ITEM FOR ENVIRONMENTAL BOARD AGENDA

**NAME AND NUMBER
OF PROJECT:** Pier Partners PUD
C814-06-0202

REQUESTS: Request to create a Planned Unit Development with
eight environmental exceptions

**STAFF
RECOMMENDATION:** Not recommended.

PROPOSED
SITE
PLAN

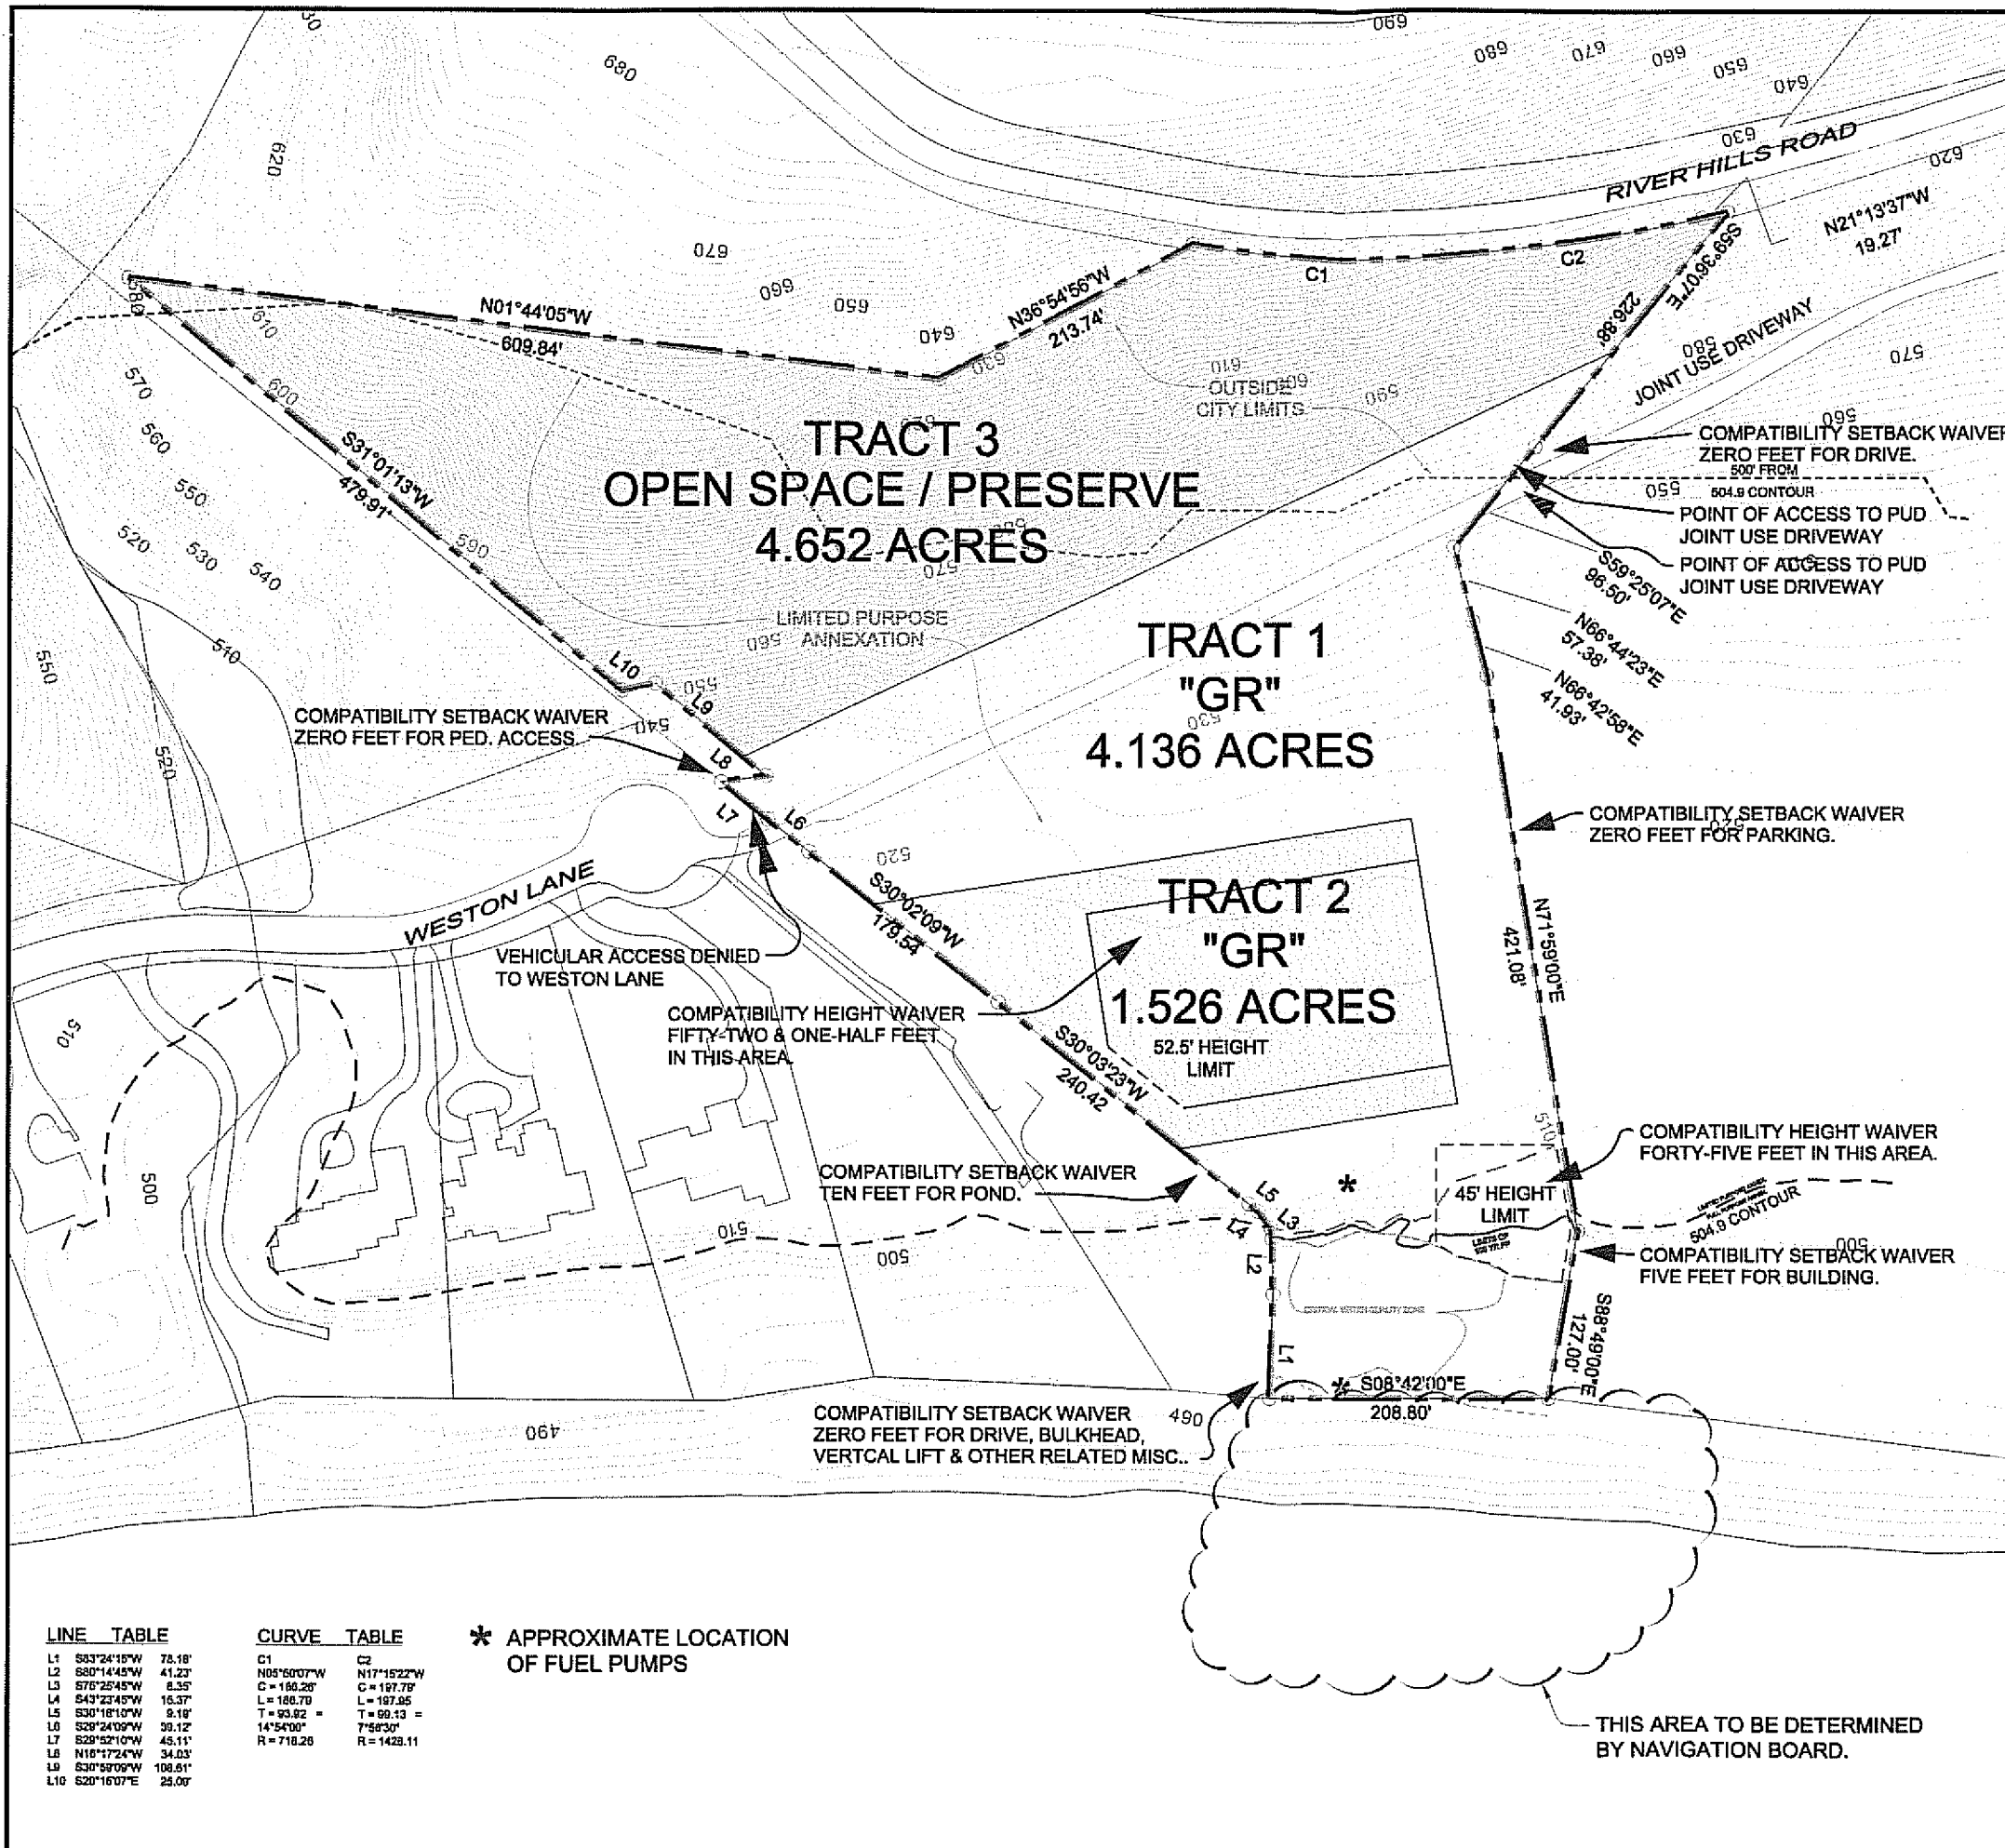
At this time, City staff cannot recommend approval of the PUD application based on the information submitted by the applicant. The proposed PUD is requesting numerous environmental exceptions, but the proposed mitigation does not provide an appropriate level of compensation for the negative environmental impacts that would occur. At this time Staff offers an alternate recommendation of CR-CO limiting the daily vehicle trips to less than 2,000 trips per day. The recommendation is subject to change based on final Staff analysis.

Request for Variance:

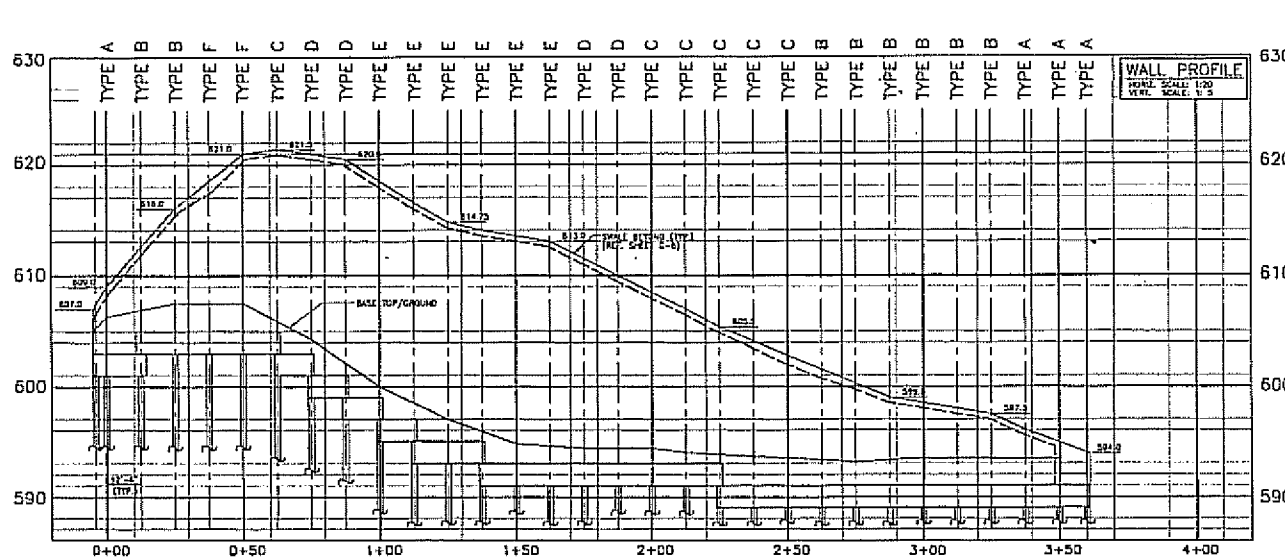
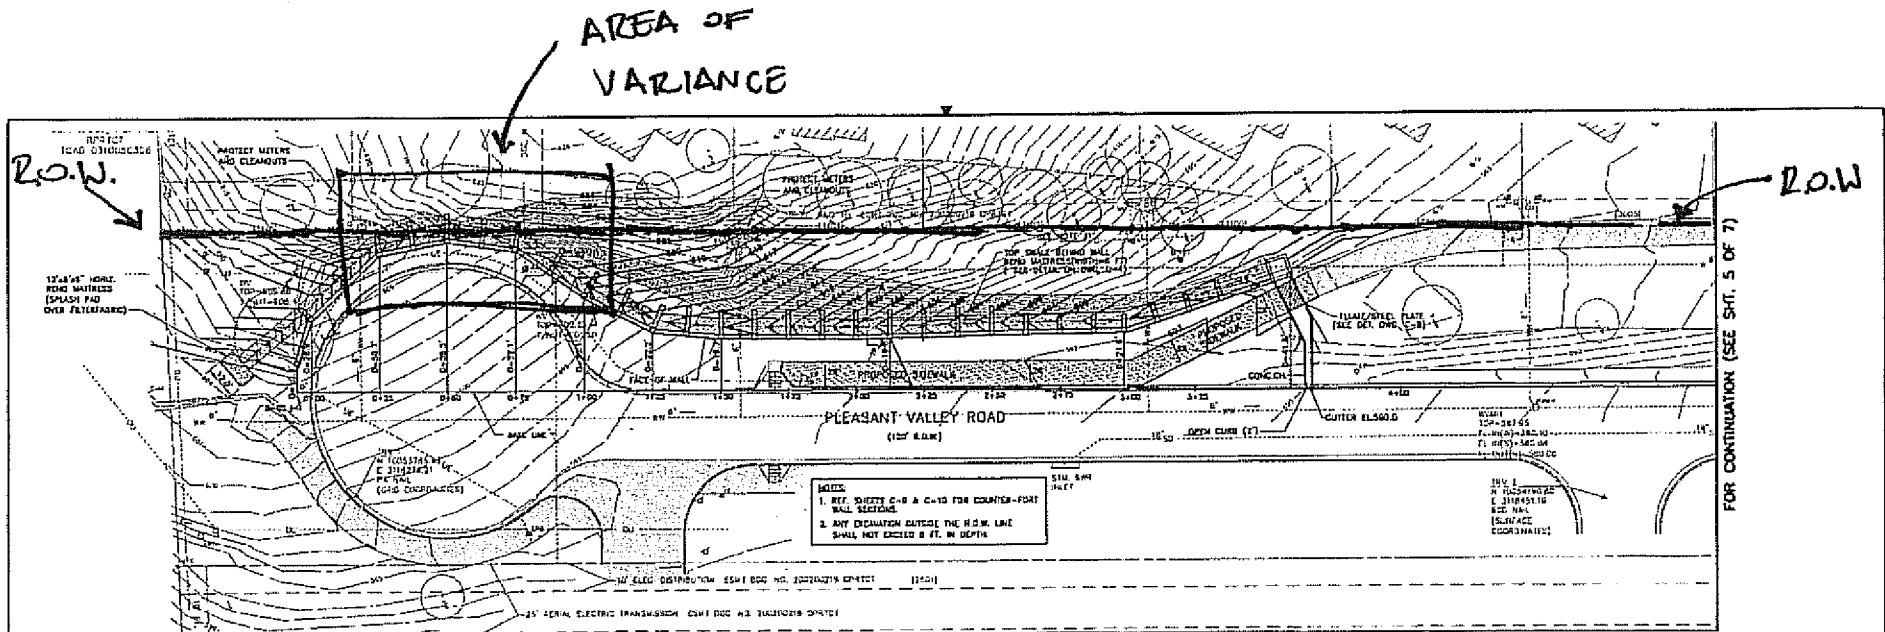
This variance is being requested because the height of the unstable slope at the cul-de-sac (approximately 22 feet from ground level) will require a counterfort retaining wall of equal height with a pier and beam foundation that will encroach on private property. Given the soils in this

area, cuts of over 15 feet will be required to stabilize the slope at a 1:1 incline. Upon completion of the construction of the retaining wall, select fill will be used to bring the slope back to its existing height. Without this requested variance, PW will not be able to construct this wall to stabilize the failing slope, remove this safety hazard and prevent future utility outages in this area.

We believe that approving this cut and fill variance for the construction of the counterfort retaining wall will result in minimal departure from minimum standards. This variance request has been coordinated with WPDRD staff in order to remove a safety hazard that poses a liability for the City of Austin.

Tree #1679 to be retained. The applicant should edit plans to preserve tree and the tree should be fertilized during construction phase to reduce the stress on tree.
